Access Compliance Report

Public Rights-of-Way

(Curb Ramps)

Intersection ID: 49931	Main Street: WOBURN_RD	Cross Street: ASHBOURNE_HALL_RD	Location: NW
ADA ID: 2FE385C27878	Ramp Type: BlendTrans1	Initial Pass/Fail: Fail	Overall Compliance: No
Severity Score: 10			
Codes/Mitigation Info/Possible Solution		Field Measurements/Component Compliance

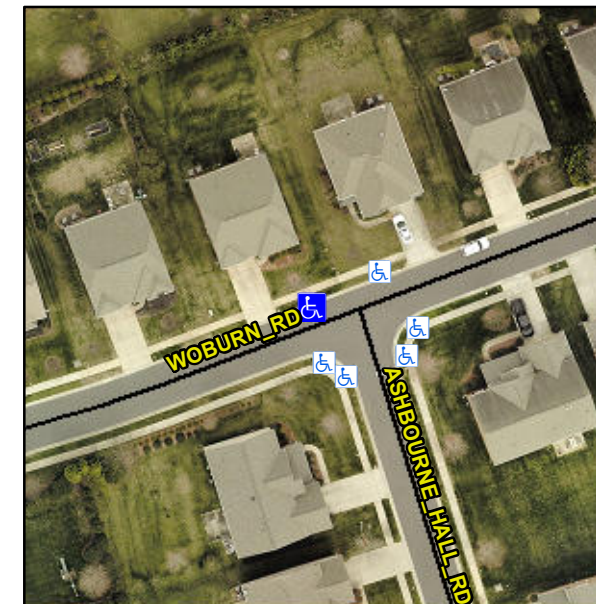
Not Found, R304.5.1, R304.5.3

Compliance	Description	Data	Compliance	Description	Data
N/A	Ramp Length (in)	46.0	Yes	BlendTrans Slope (%)	4.5
No	Ramp Width (in)	47.0	No	BlendTrans XSlope (%)	3.6
N/A	Flare Type LT	N/A	N/A	Flare Type RT	N/A
N/A	Flare Slope LT (%)	N/A	N/A	Flare Slope RT (%)	N/A
N/A	Flare Traversable LT?	N/A	N/A	Flare Traversable RT?	N/A
N/A	Landing Length (in)	N/A	N/A	DWS Provided?	N/A
N/A	Landing Width (in)	N/A	N/A	DWS Contrast?	N/A
N/A	Landing Slope (%)	N/A	N/A	DWS Length (in)	N/A
N/A	Landing X Slope (%)	N/A	N/A	DWS Full Width?	N/A
N/A	Landing Curb? (Y/N)	N/A	N/A	DWS Offset (in)	N/A
N/A	Shared Landing?	N/A			
N/A	Gutter Ponding?	N/A	N/A	Gutter Slope (%)	N/A
N/A	Gutter Lip Ht (in)	N/A	N/A	Gutter X Slope (%)	N/A
N/A	Painted X Walk1?	No	N/A	Painted X Walk2?	N/A
	X Walk 1 Direction	To SE		X Walk 2 Direction	N/A
	X Walk 1 Width (in)	N/A		X Walk 2 Width (in)	N/A
	X Walk 1 Slope (%)	2.5		X Walk 2 Slope (%)	N/A
	X Walk 1 X Slope (%)	3.5		X Walk 2 X Slope (%)	N/A

N/A	Ramp inside XWalk1?	N/A	N/A	Ramp inside XWalk2?	N/A
	Road Slope (%)	3.5		Clear Space?	N/A
	Road X Slope (%)	2.5	N/A	Clear Space to XWalk (in)	N/A
N/A	Any Obstructions?	N/A	N/A	Storm Grate/Utility Hazard?	N/A
	Obstruction Type			Storm Grate/Utility Type	
		N/A			N/A
			Yes	Surface Condition? (G/P)	Good
			No	Curb Slope (%)	10.1

Remove & Replace Curb Ramp With Two New Directional Ramps or Equivalent.
